# UNITED STATES PATENT AND TRADEMARK OFFICE

| APPLICATION NO. | FILING DATE | FIRST NAMED INVENTOR | ATTORNEY DOCKET NO. | CONFIRMATION NO. |
|-----------------|-------------|----------------------|---------------------|------------------|
| 10/716,748      | 11/19/2003  | Ronald G. Polcawich  | ARL 03-09           | 7460             |

## **DETAILED ACTION**

U.S. Patent Feb. 19, 2002 Sheet 3 of 7 US 6,348,968 B2

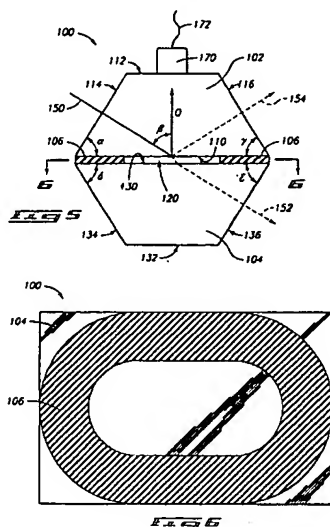
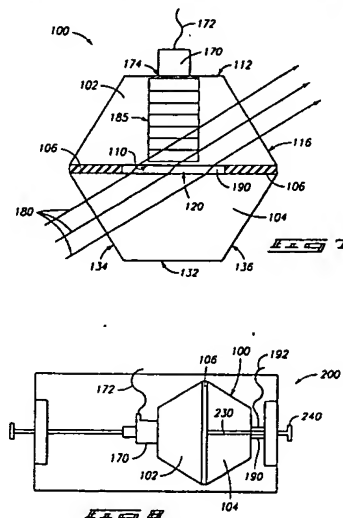
**Claim 26 is rejected under 35 U.S.C. 102(b) as being anticipated by Autrey et al (U.S. Patent No. 6,348,968).**

**Regarding claim 26;** Autrey et al discloses an integrated photoacoustic spectroscopy cell, comprising:

photoacoustic spectroscopy cell (100 of figure 5) having a multi-layer structure (102, 106, 104 of figure 5) for receiving a gas sample (col.6 lines 21-26) for the spectroscopy cell (100 of figure 5) and having an inner layer (106 of figure 5 is shim material) disposed between top and bottom outer layers (i.e., first block material [102 of figure 5] and second block material [104 of figure 5]), with the inner layer (106 of figure 5) being patterned to form a resonance cavity (center sample reservoir [120 of figure 5]); and

a thin-film membrane microphone (i.e., a transducer is preferably an acoustic microphone [col.2 line 50 to col.3 line 12 and col.8 line 66 to col.9 line 5]) formed on one of the outer layers (102 of figure 7) and acoustically coupled to the resonant cavity (120 of figure 7). See figures 1-13.

U.S. Patent Feb. 19, 2002 Sheet 3 of 7 US 6,348,968 B2

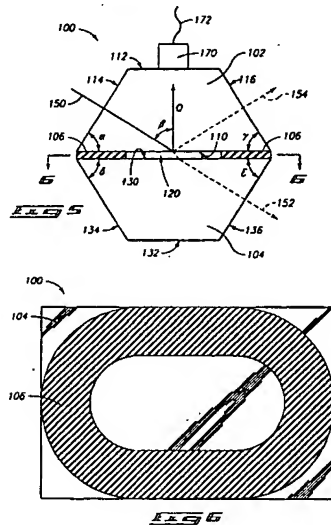
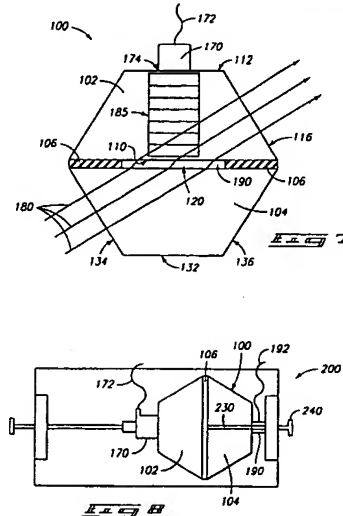
**Regarding claim 23;** Autrey et al discloses an integrated photoacoustic spectroscopy cell, comprising:

photoacoustic spectroscopy cell (100 of figure 5) having a multi-layer structure (102, 106, 104 of figure 5) for receiving a gas sample (col.6 lines 21-26) for the spectroscopy cell (100 of figure 5) and having an inner layer (106 of figure 5 is shim material) disposed between top and bottom outer layers (i.e., first block material [102 of figure 5] and second block material [104 of figure 5]), with the inner layer (106 of figure

5) being patterned to form a resonance cavity (center sample reservoir [120 of figure 5]); and

a thin-film membrane microphone (i.e., a transducer is preferably an acoustic microphone [col.2 line 50 to col.3 line 12 and col.8 line 66 to col.9 line 5]) formed on one of the outer layers (102 of figure 7) and acoustically coupled to the resonant cavity (120 of figure 7). See figures 1-13.

U.S. Patent Apr. 25, 2006 Sheet 1 of 8 US 7,034,943 B1

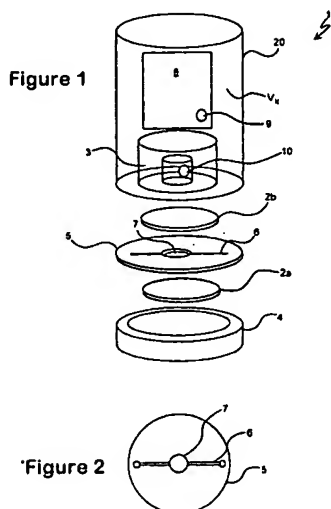
Autrey et al discloses all of features of claimed invention except for the inner layer being patterned to include an open tube resonant cavity with buffer cavities from on either side thereof. However, Moeckli et al teaches that it is known in the art to provide photoacoustic detector (1 of figure 1) having the inner layer (5 of figure 1) being patterned (figure 1) to include an open tube resonant cavity (6 of figures 1-2) with buffer cavities (figure 2) from on either side thereof. See figures 1-9.

It would have been obvious to one having ordinary skill in the art at the time the invention was made to combine device of Autrey et al with the inner layer being patterned to include an open tube resonant cavity with buffer cavities from on either side thereof as taught by Moeckli et al for the purpose of reducing signal-to-noise ratios in photoacoustic detectors and other gas sensors to maintain an adequate response time to changing gas concentration levels.
